ADDENDUM NO. 3

DATE: July 28, 2014

RE: Hemisfair Historic Homes
Stabilization and Rehabilitation

Architect's Project No: 1312 A1

SHEET NO.
6-A1

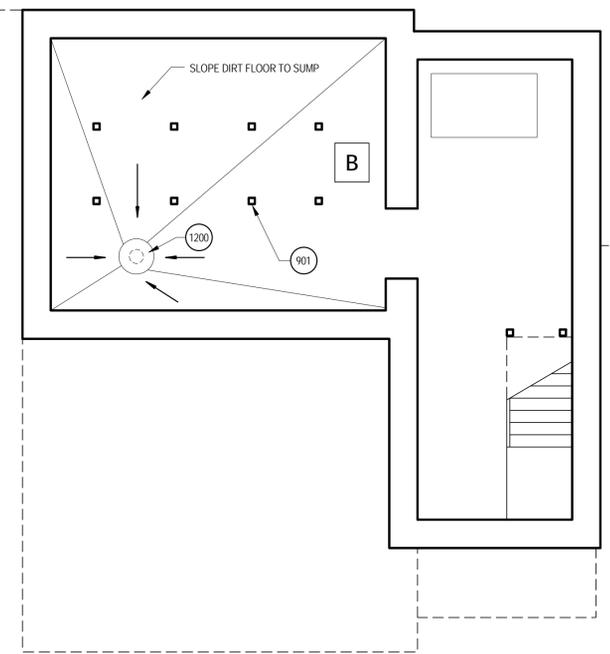
1. Mayer/ Half House Building 308 - Door 'D2' on Sheet 5-A1 (plan and schedule) and on Sheet 5-A6 to be re-built utilizing as much original historic fabric as possible (as noted on above sheets).
2. Kampmann House Building 235 – Remove existing and repair flooring as required to complete structural repair, refer to the attached 6-A1.

3. Sheet 6-A1, 2 -Basement Plan, note 901 state to see structural for replacement of deteriorated column. Could not find anything on structural to indicate what size and type of column we are to use to replace with. Please provide information on this column.

Response: Note 901 shall read "REPLACE DETERIORATED COLUMN TO MATCH EXISTING".

3 SECTION
SCALE : 1/2" = 1'-0"

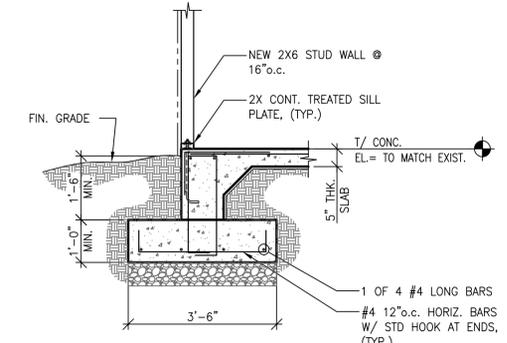
9. 16-S1-Add following note under section 3/16-S1-Contractor to provide 6" minimum to 8" maximum flowable fill material.
10. 6-S1-Deleted hatch on existing stone wall that did not have a new footing on first floor plan. See revised sheet.

2 SECTION
SCALE : 1/2" = 1'-0"

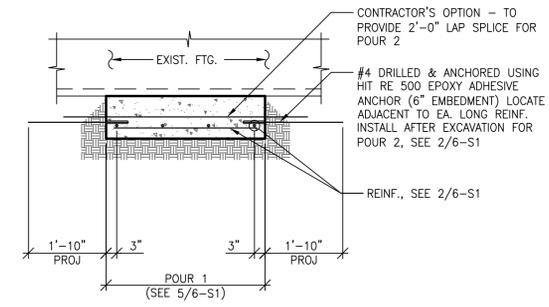
4. Sheet 6-S1 Detail 2 Section, describes providing flowable fill. There is no depth given, what is the depth?

7. 7-S3-Delete note #2 on plan notes. Selective structural repair area consists of all new framing as indicated on plans.
8. 6-S1-Add following note under section 2/6-S1-Contractor to provide 6" minimum to 8" maximum flowable fill material.

Response: See attached narrative from Alpha Consulting Engineers dated July 25, 2013.
